M E M O R A N D U M

TO: Historic Preservation Commissioners
FROM: Alison B. Vawter *Alison*
SUBJECT: Possible Permit Violations at 10215 Menlo Avenue, Silver Spring
(Reference HPC Case No. 31/7-90C, heard April 25, 1990)
DATE: August 7, 1990

OUTLINE OF MODIFICATIONS 10215 MENLO AVE.

selected door

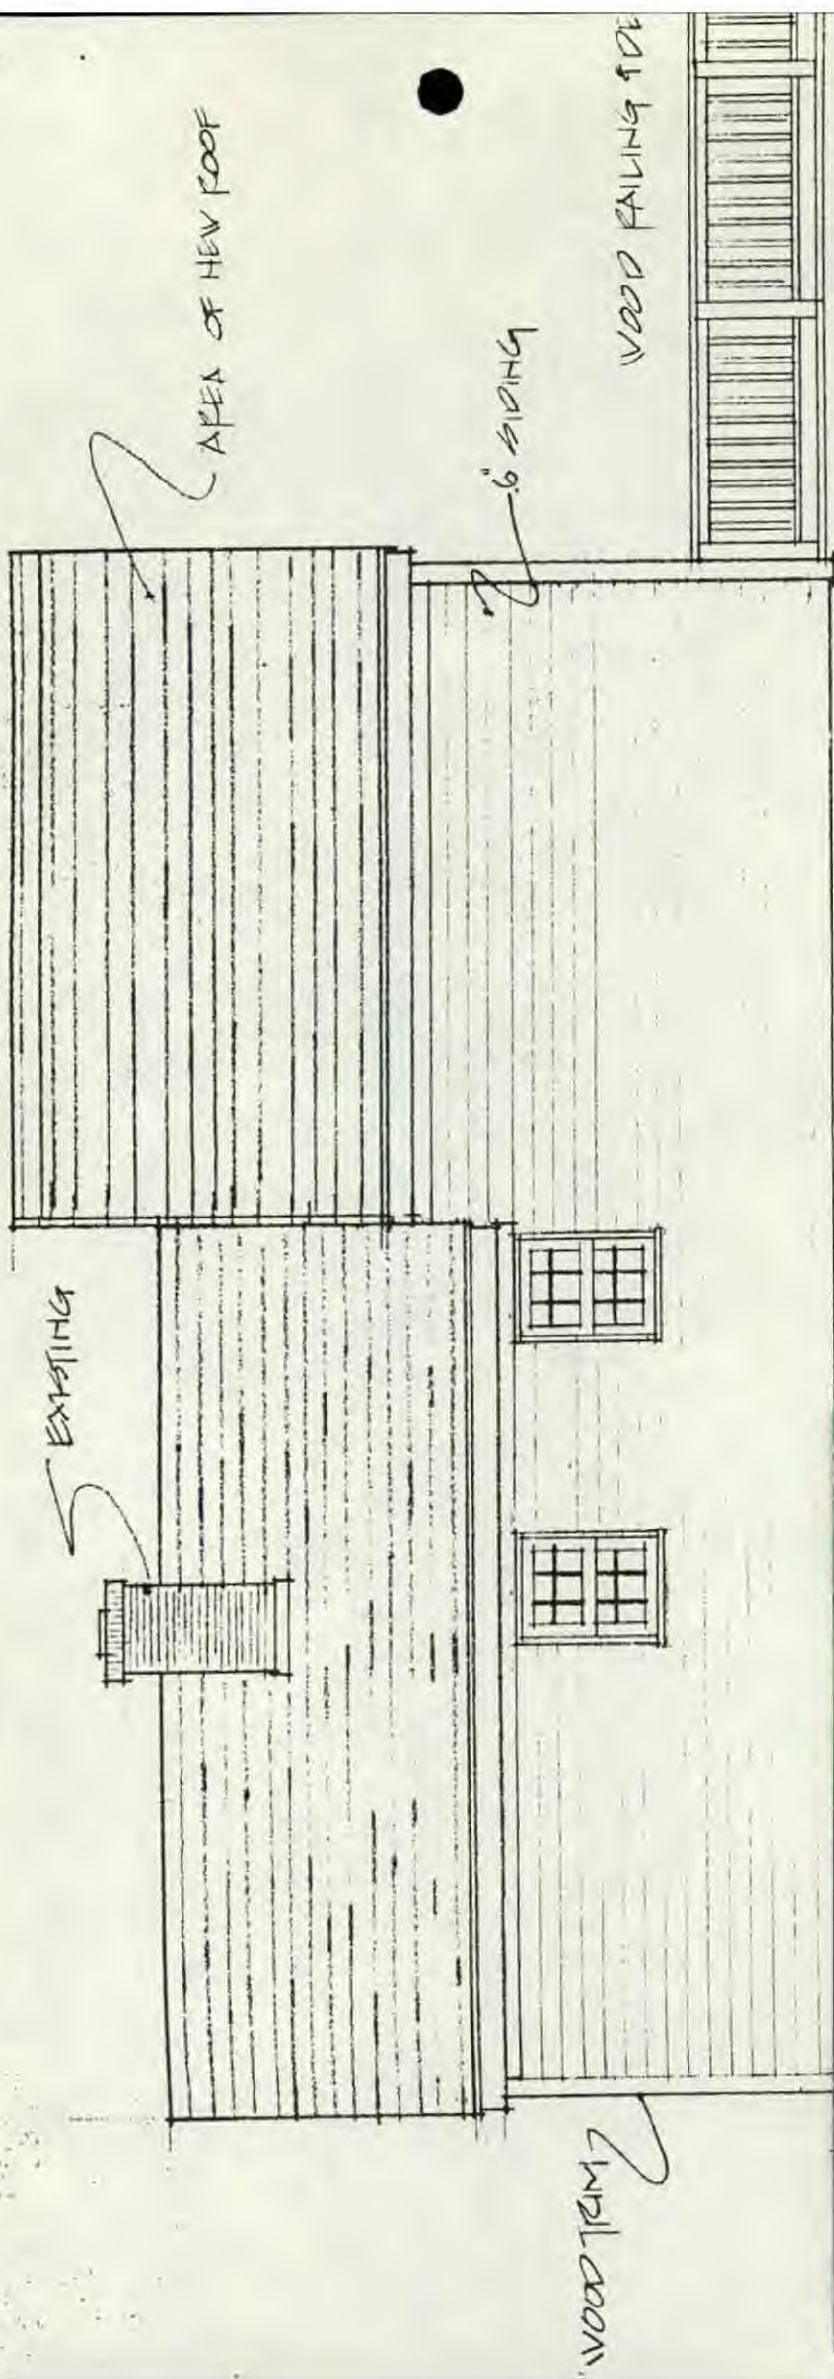
11. The front door style has been selected and it differs from the picture drawn on the original plans.

Reason: That was a kind of "generic" door that had not been specifically selected at time of plan submittal. Enclosed is a photo copy of the door style selected.

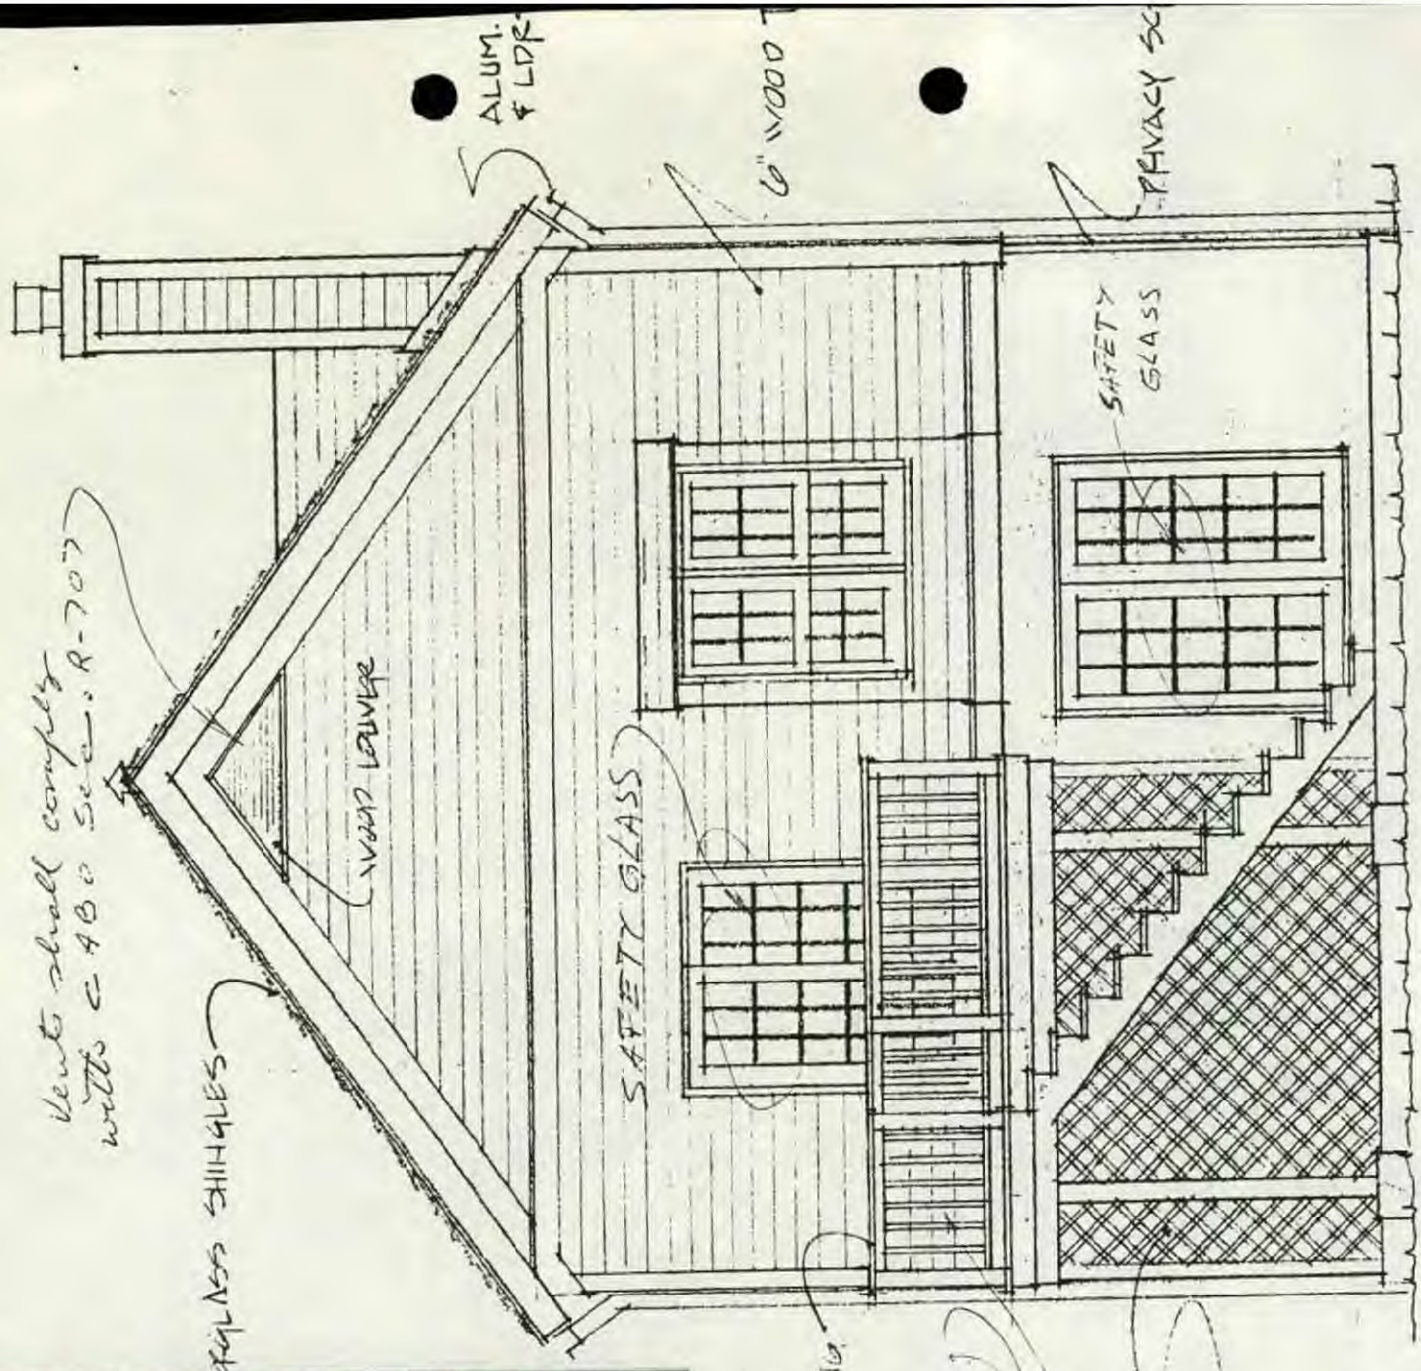
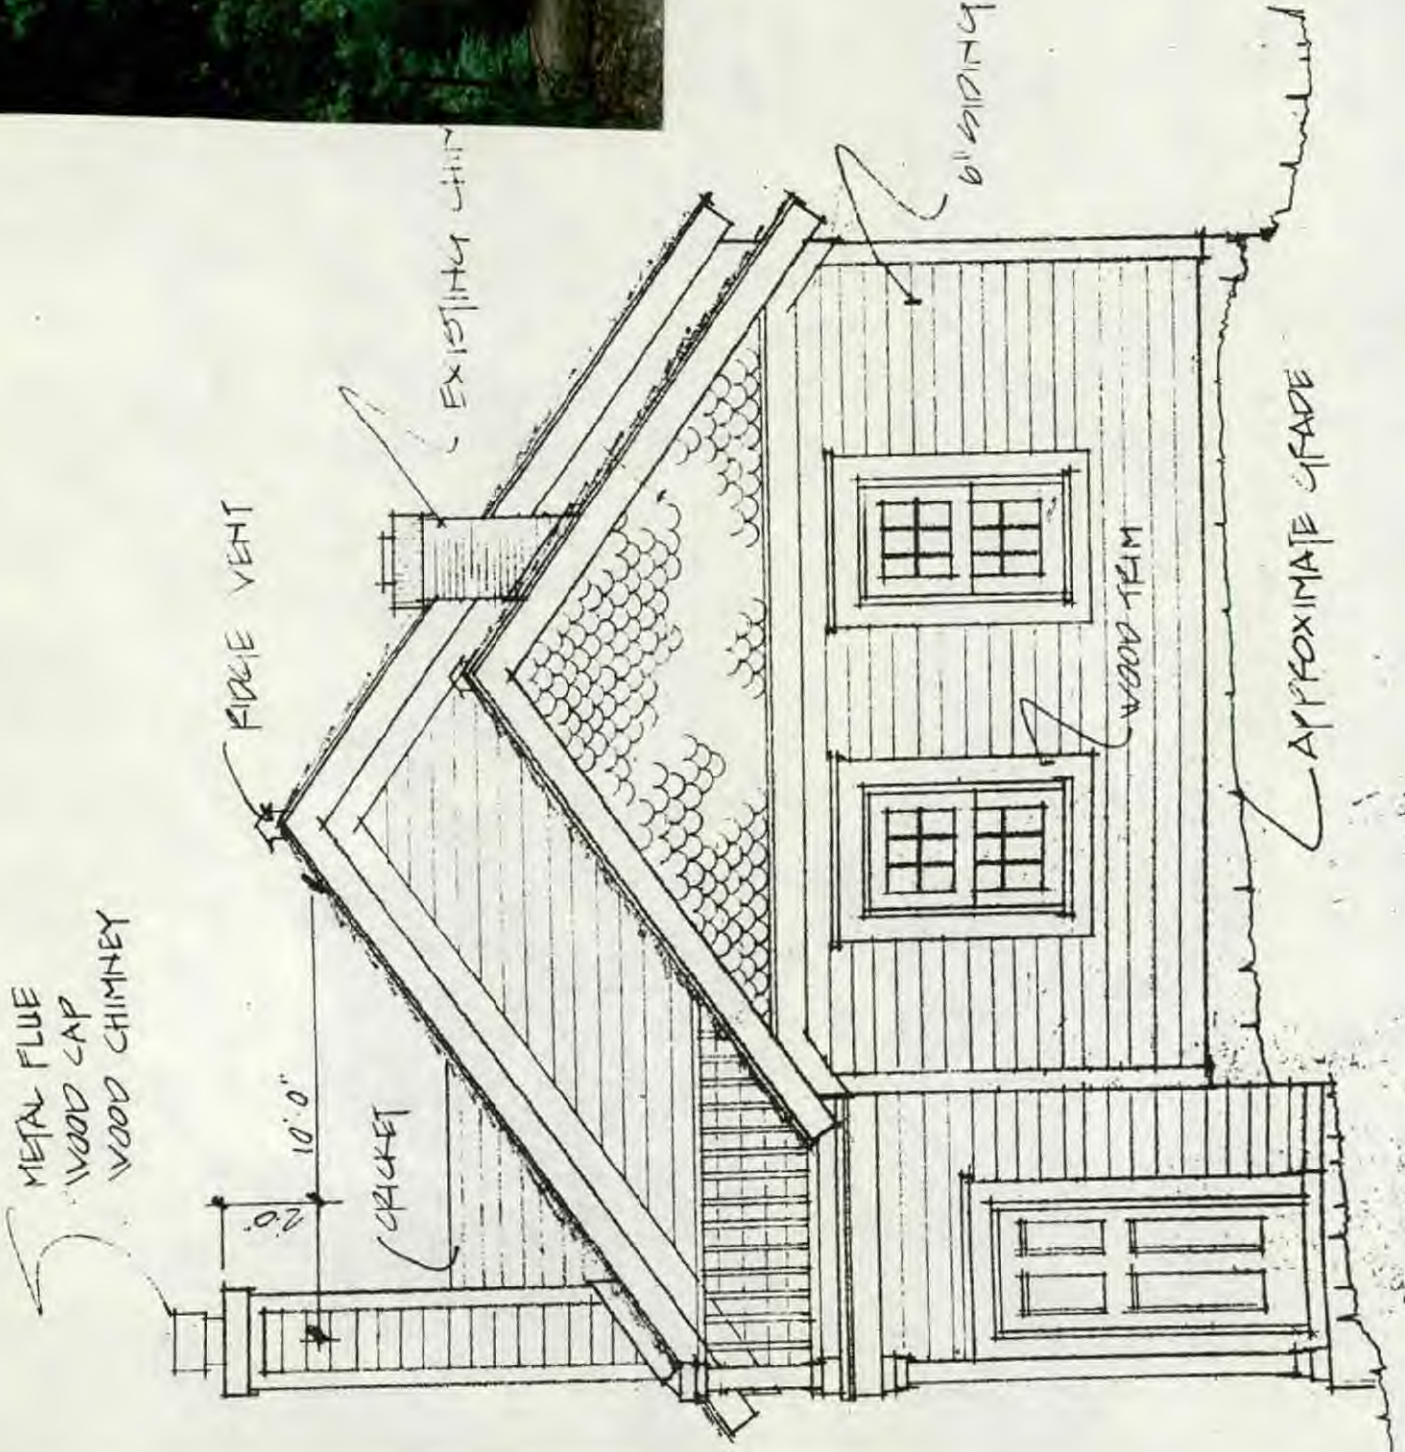
9. In the area under the deck it has been advised that we build a storage space between the area that was shown as lattice.

Reason: There is no garage or full basement in this home and the addition of additional storage for lawn and other equipment would be helpful.

10. The double window facing the rear yard has a gable roof projection instead of shed roof projection as originally shown.

Reason: At time of installation the shed roof projection of 10" looked inappropriate so a gable projection of 10" was re-built mirroring the same pitch as the main roofs.

REAR ELEVATION

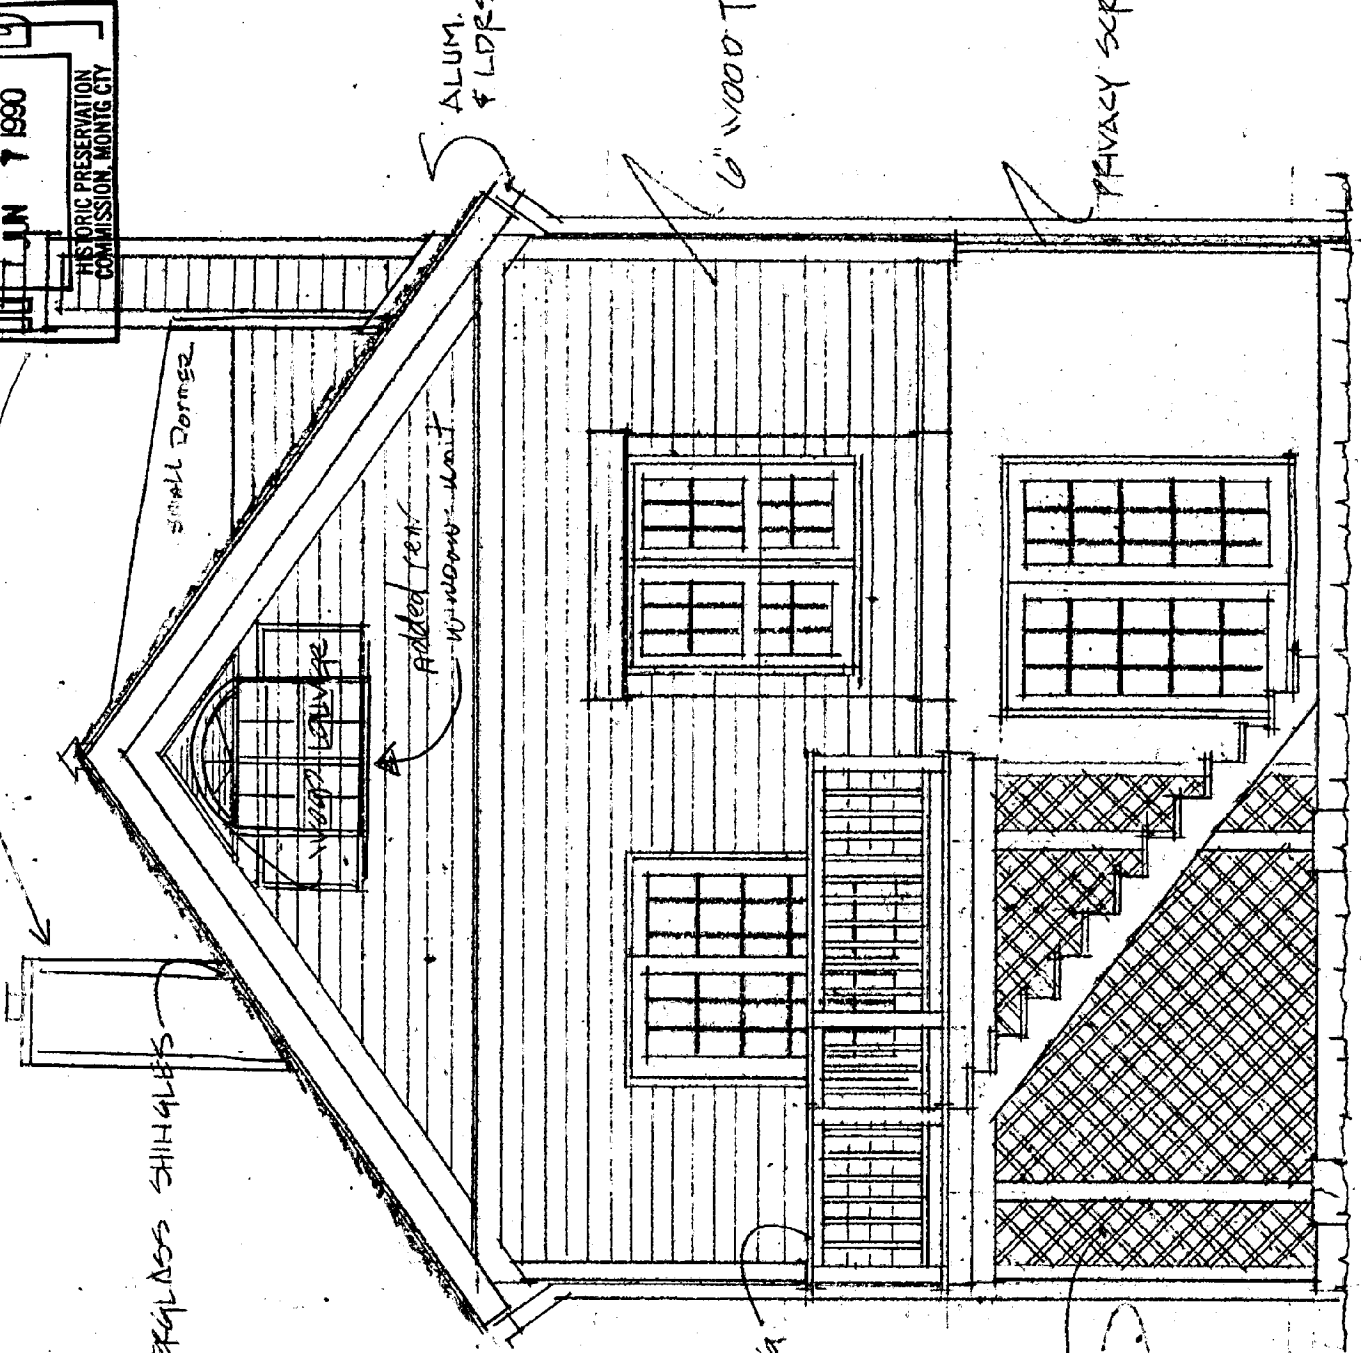
1. The new front gable will be sided with cedar shingles as is the original gable in the approved design. The shingles look so nice on the smaller original gable we decided to continue them on the new area instead of the masonite siding. The front gable louver has been changed to a similar sized half round window.

2. The "attic" space that was created by the new gable roof (over the existing shed roof) was so nice that it was decided to utilize this space. Consequently the rear gable end louver has been changed to a Palladium style window unit and two skylights on the north side new roof have been added. Code requirements for ceiling ht. made it necessary to add a small shed dormer roof where the original roof cricket was.

3. The fireplace had to be relocated so the chimney now comes through the south instead of the north side of the new gable roof.
- There have been no changes in scale or dimensions from the approved design.
